APPEAL SUMMARY

Appeal ID: 21942	Project Address: 200 NW Royal Blvd, Lot #4
Hearing Date: 10/2/19	Appellant Name: Robert Oshatz
Case No.: B-005	Appellant Phone: 5036354243
Appeal Type: Building	Plans Examiner/Inspector: Jill Grenda, Nancy Thorington, Stacey Castleberry, Eric Engstrom
Project Type: residential	Stories: 3 Occupancy: R Construction Type: V-B
Building/Business Name: RHO LLC	Fire Sprinklers: No
Appeal Involves: Reconsideration of appeal	LUR or Permit Application No.: 06-107711-LU
Plan Submitted Option: pdf [File 1] [File 2] [File 3] [File 4] [File 5]	Proposed use: Single family residence

APPEAL INFORMATION SHEET

Appeal item 1

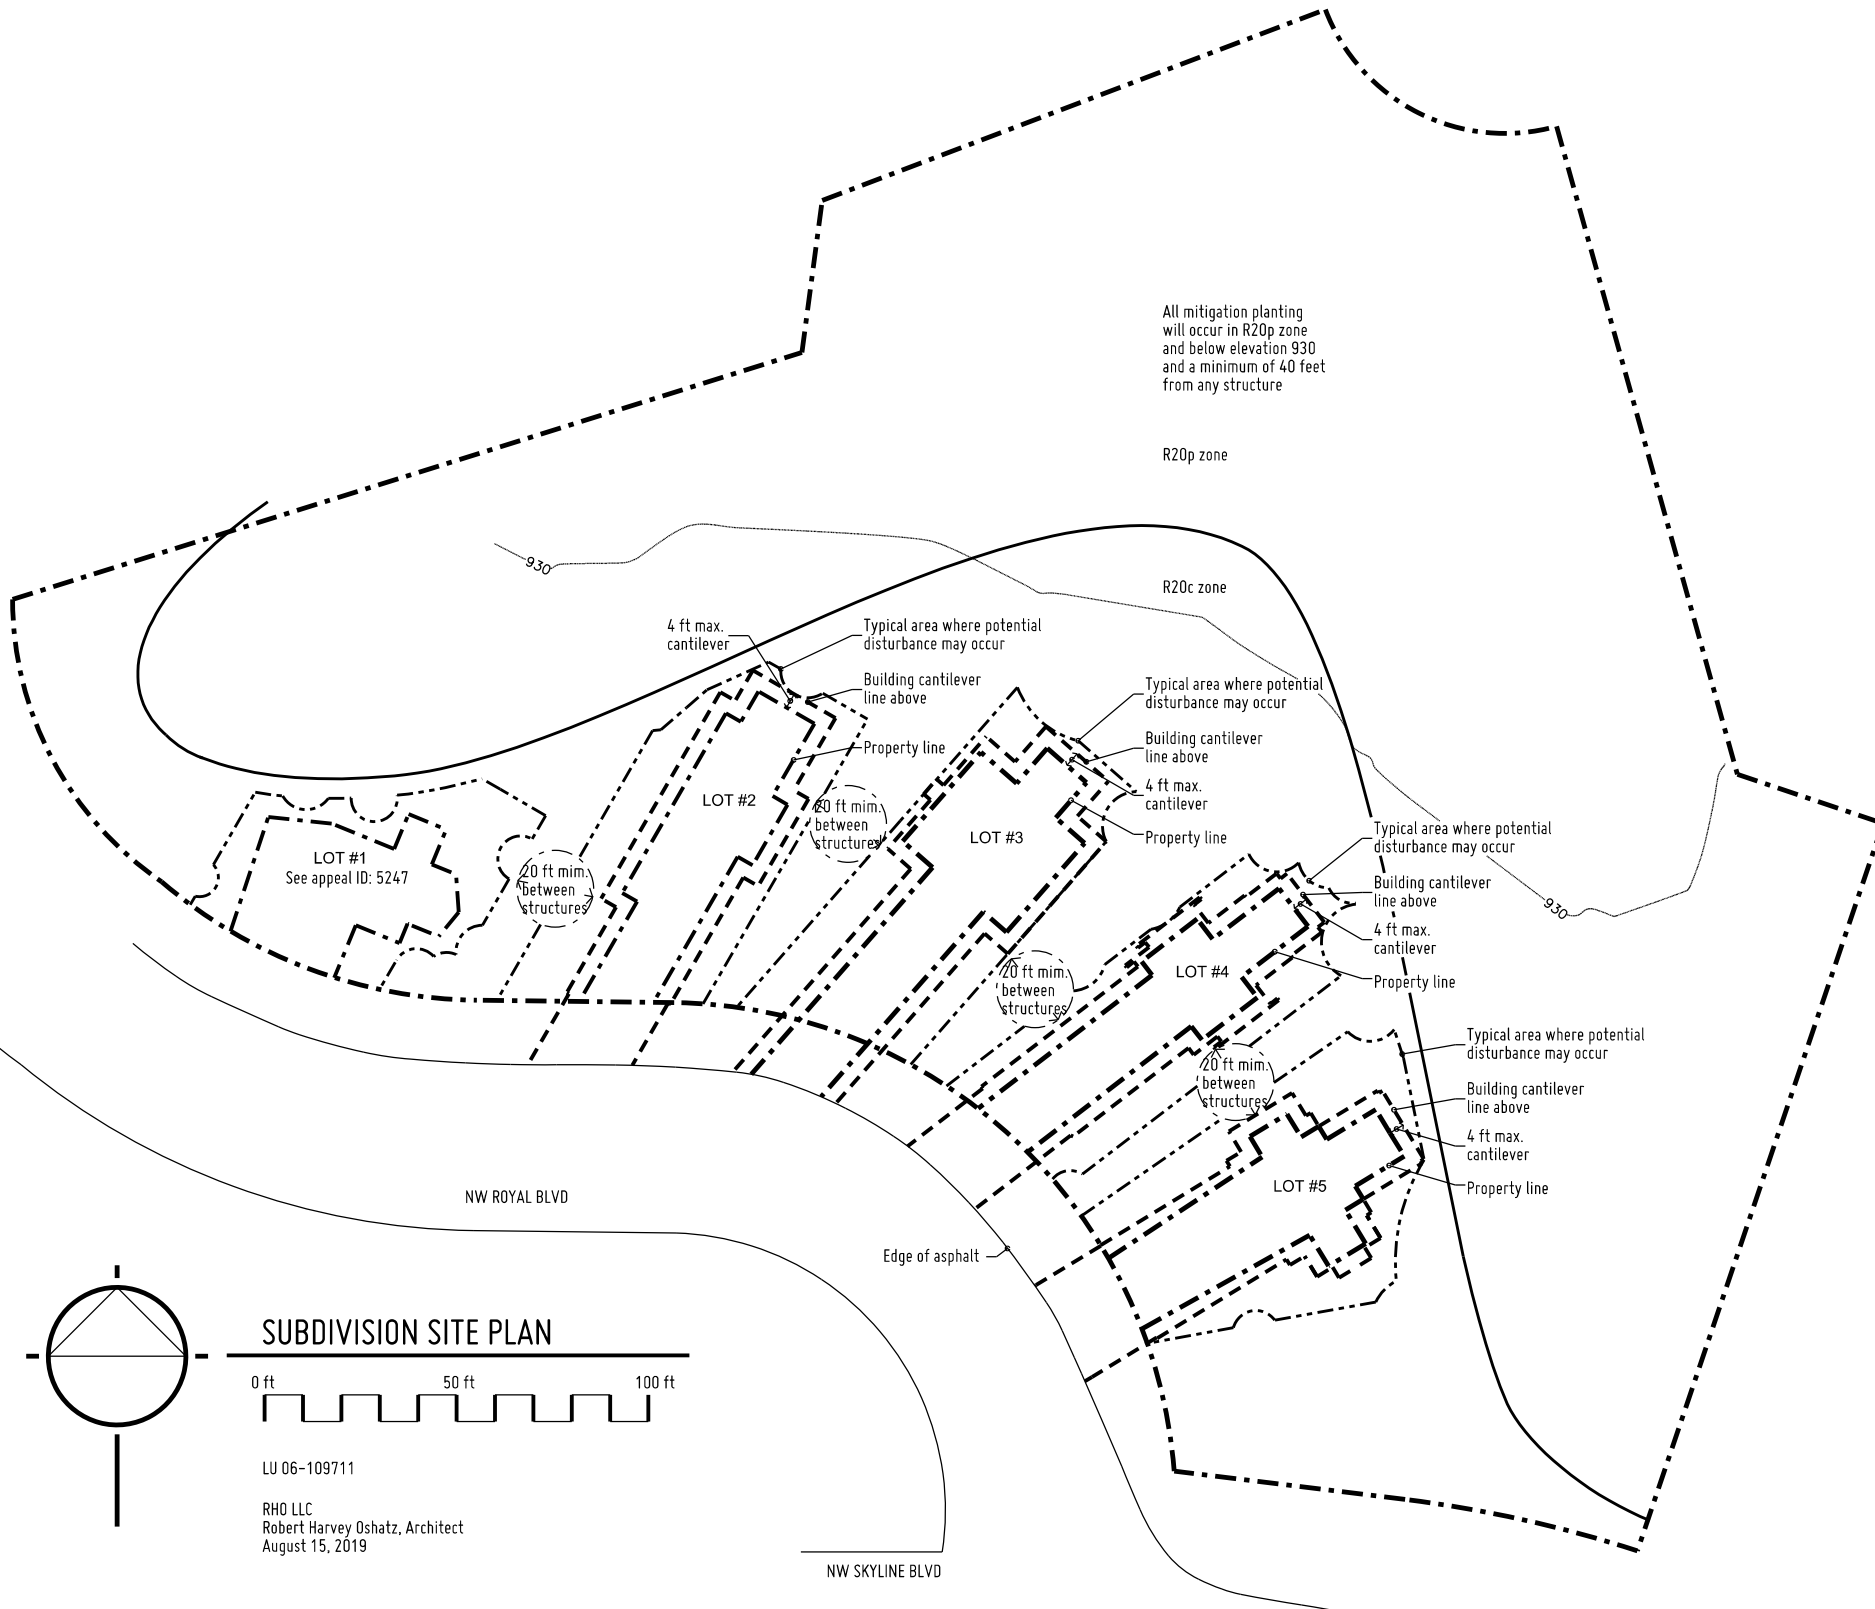
Section R302.1 of the 2005 Oregon Residential Specialty Code is concerned with public safety. It requires that openings are not permitted less than 3 feet from a property line. Essentially this results in a separation of openings between structures of at least 6 feet to prevent fire spreading. In this appeal, for Lot #4 will be at least 20 feet away from any future structure on Lot #3 and Lot #5 (as required by the subdivision approval). This is greatly exceeding the 6 feet suggested by R302.1. Thus, the design follows the intent of the code and more than satisfies it.

I feel code guide OSSC/32/#1 should not apply in this case. In the past it has been targeted for cantilevering into public common areas that is used by the public. This is a case where the structure is cantilevering into its own privately not open to the public green space. When the subdivision is look at with its private common green space (which is not open to use by the public and since the site is steeply sloping and the structures are not design for their occupants to use the private common green space) in essence the house is meeting the concerns of a residence built in a R20 zone. In reality except to meet zoning requirements of an environmentally sensitive site the property lines are imaginary (in essence the planning department is saying this by going along with the concept of cantilevering over the property lines and requiring the residence to be a minimum of 2,000 sf).

Openings in exterior walls at property line: Granted as proposed.

The Administrative Appeal Board finds that the information submitted by the appellant demonstrates that the approved modifications or alternate methods are consistent with the intent of the code; do not lessen health, safety, accessibility, life, fire safety or structural requirements; and that special conditions unique to this project make strict application of those code sections impractical.

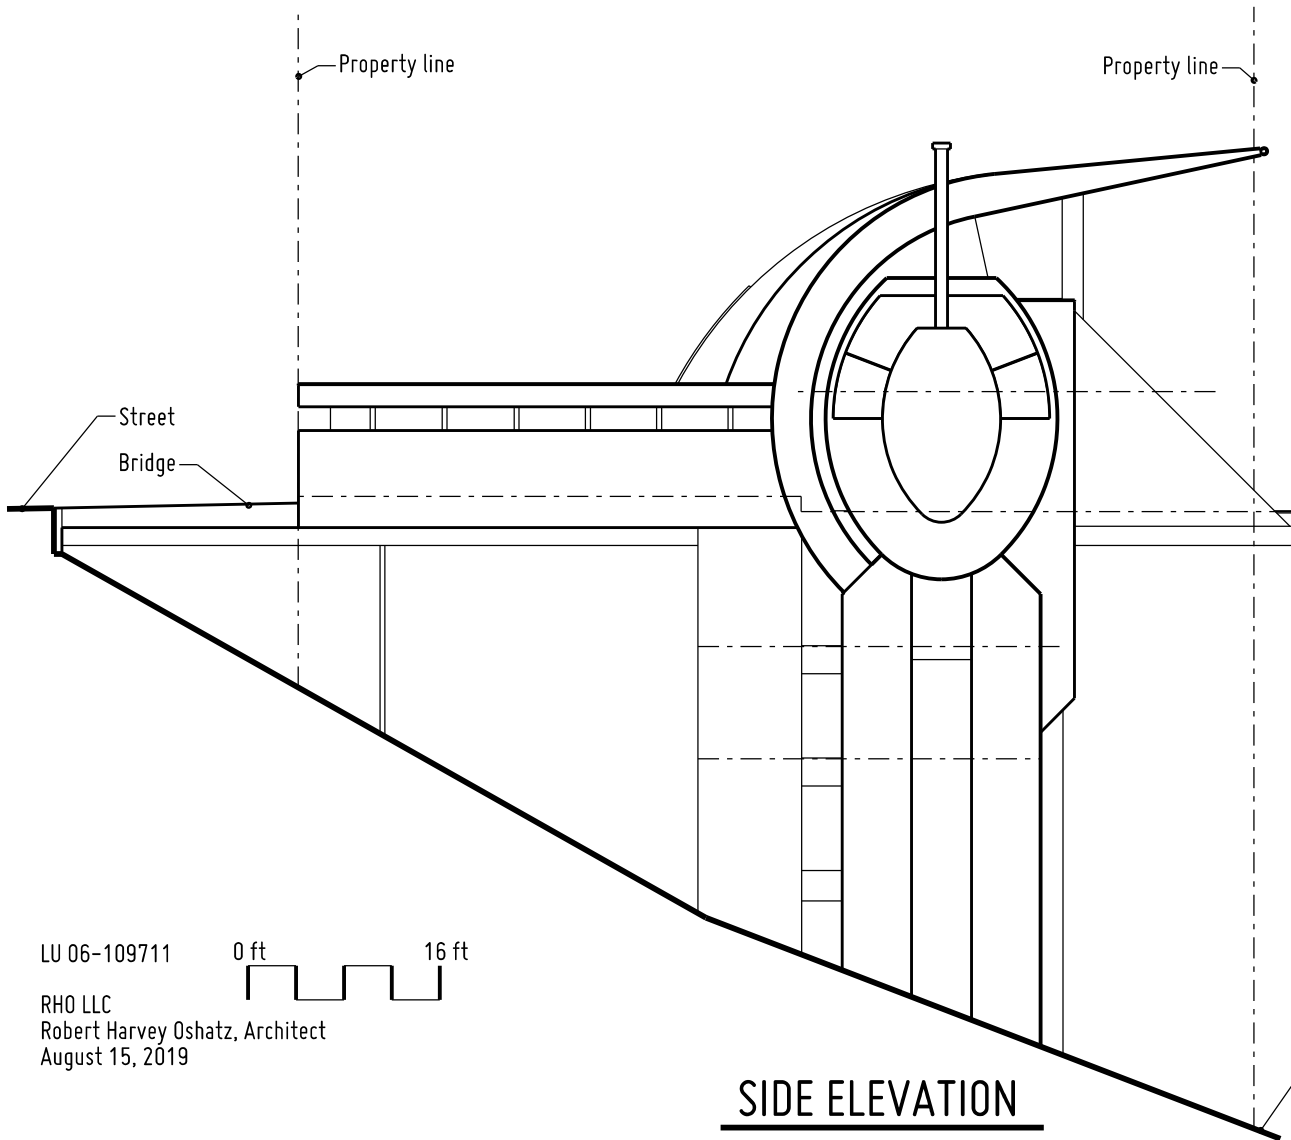
The cantilever deck which will be constructed of steel beams, 4x14 joist and 2x6 outdoor decking; the roof will be Class B materials, the walls are cad in sheet-metal, wood and stucco and soffits will be 5/8" fire rated gypsum board; making the structure at least as safe as any other residence in the neighbor. In addition, I am willing to work with the Fire Marshall's office to mitigate any of their concerns.
